ROXBOROUGH VILLAGE METROPOLITAN DISTRICT

141 Union Boulevard, Suite 150
Lakewood, Colorado 80228-1898
Tel: 303-987-0835 × 800-741-3254
<https://www.roxboroughmetrodistrict.org/>

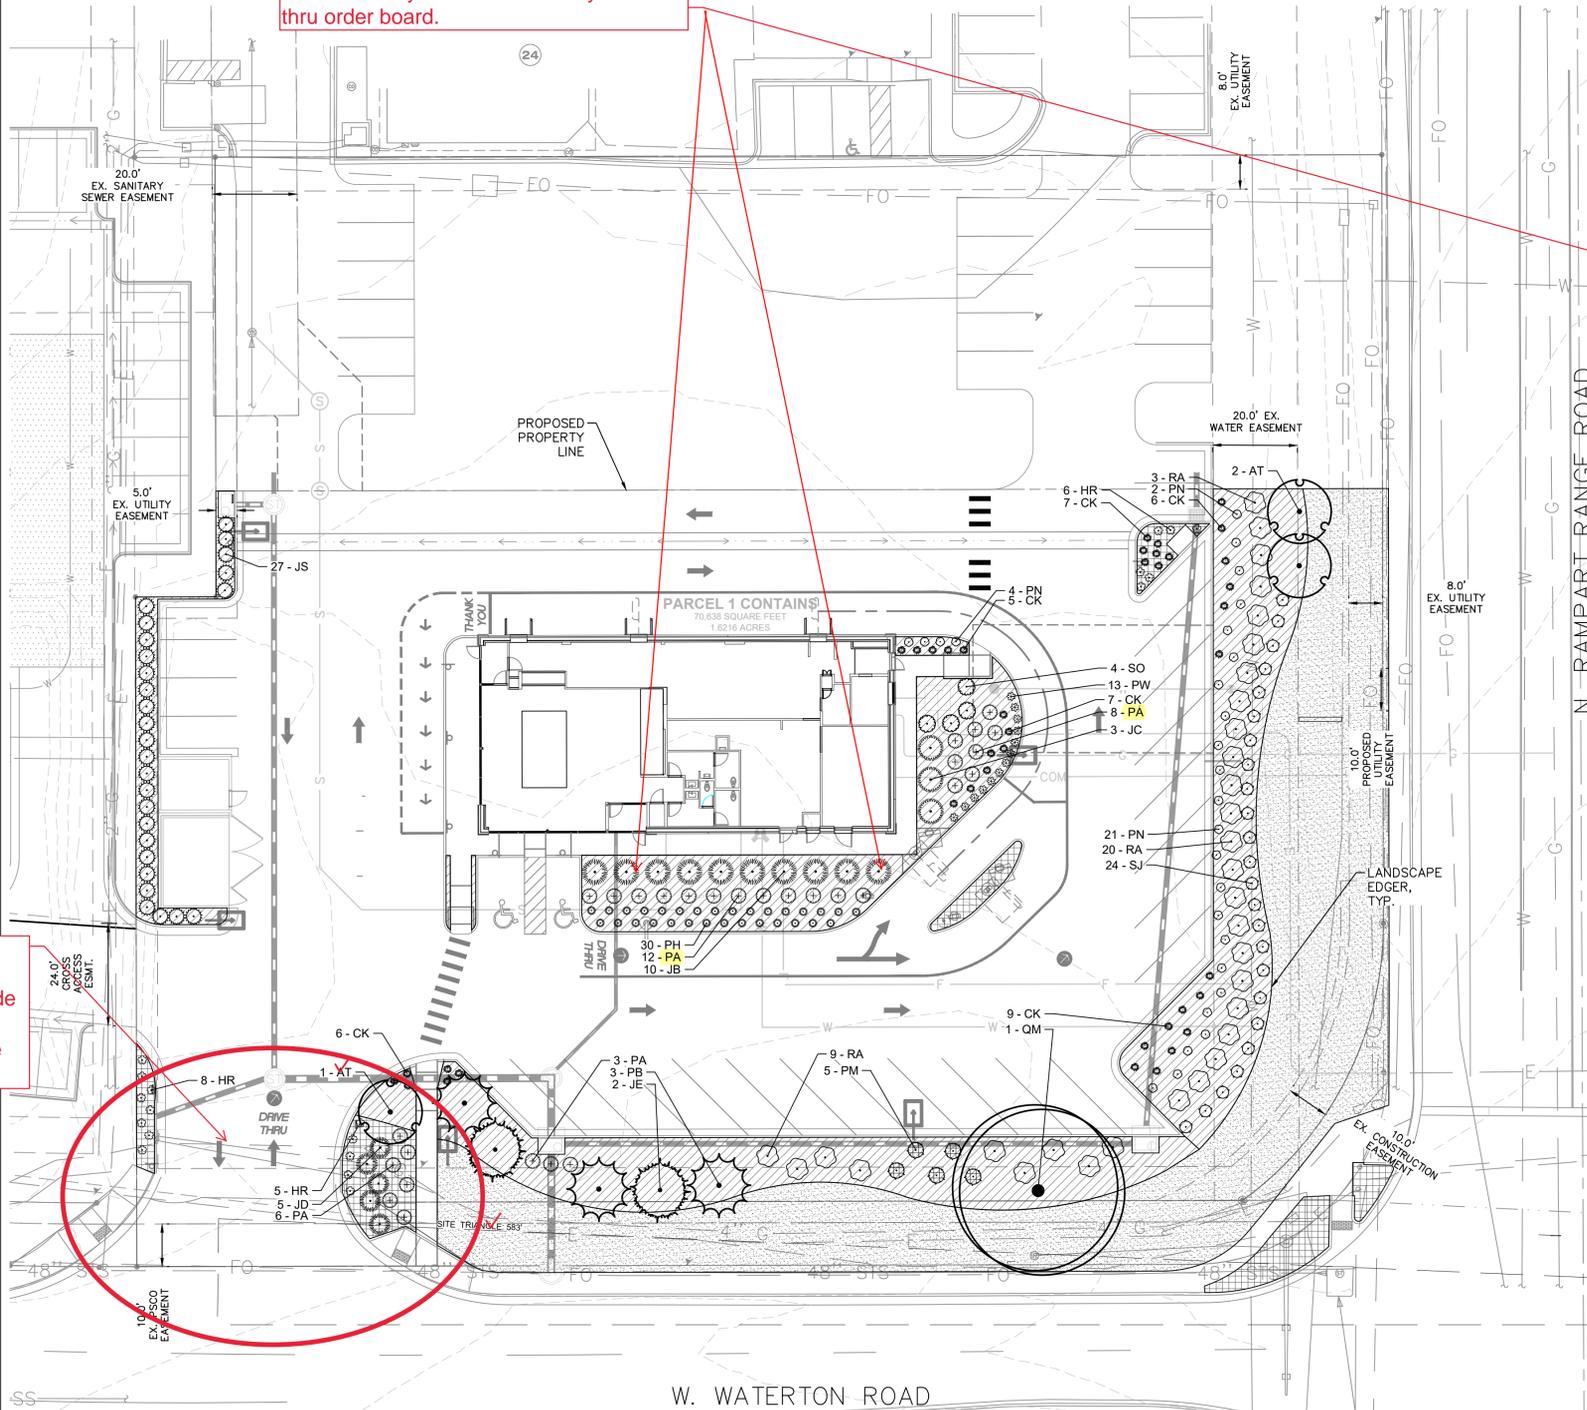
KH Response: Noted, all Russian Sage on the site has been replaced with other plants.

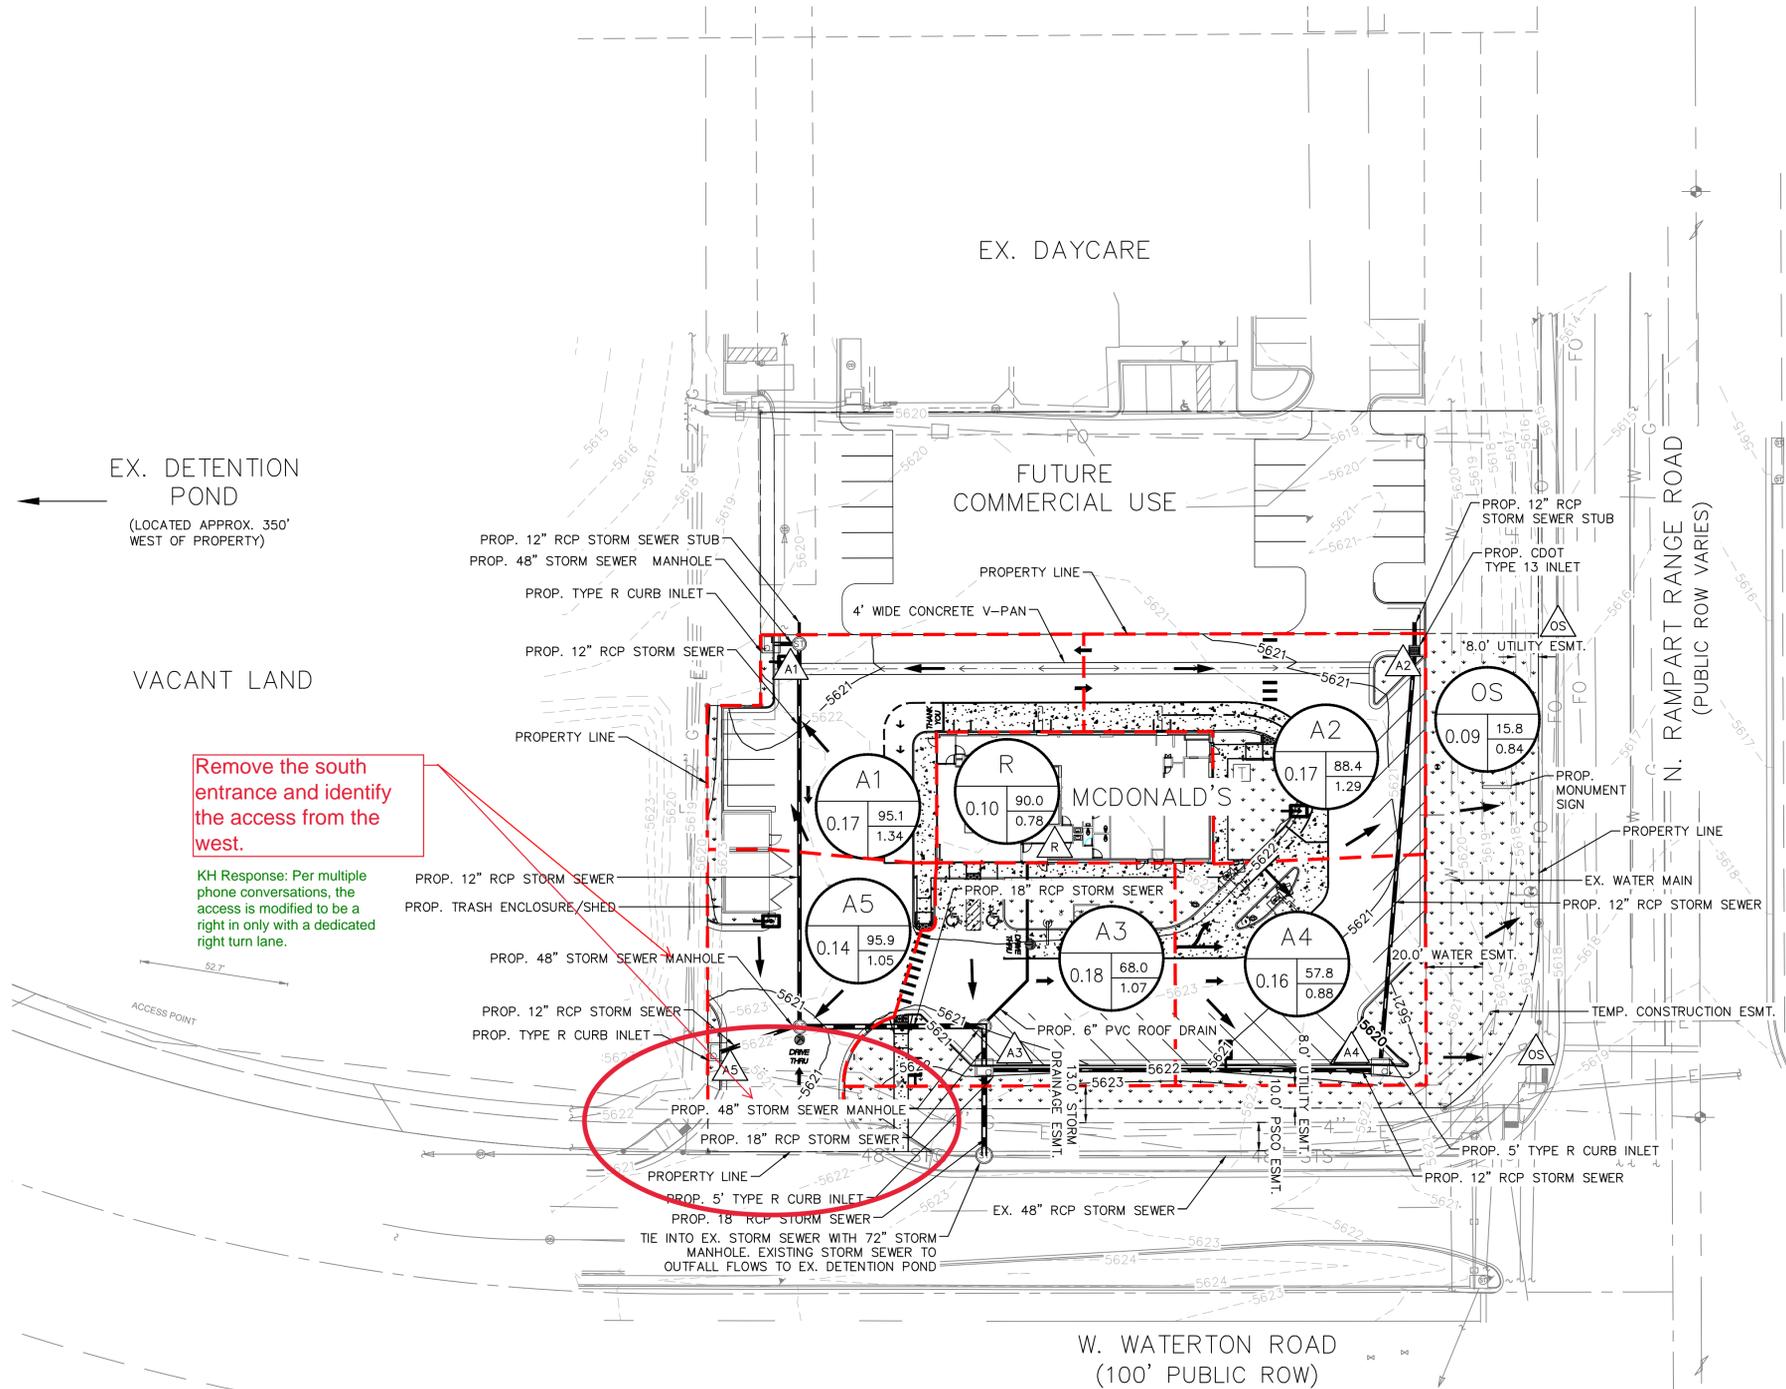
KH Response: Per multiple phone conversations, the access is modified to be a right in only with a dedicated right turn lane.
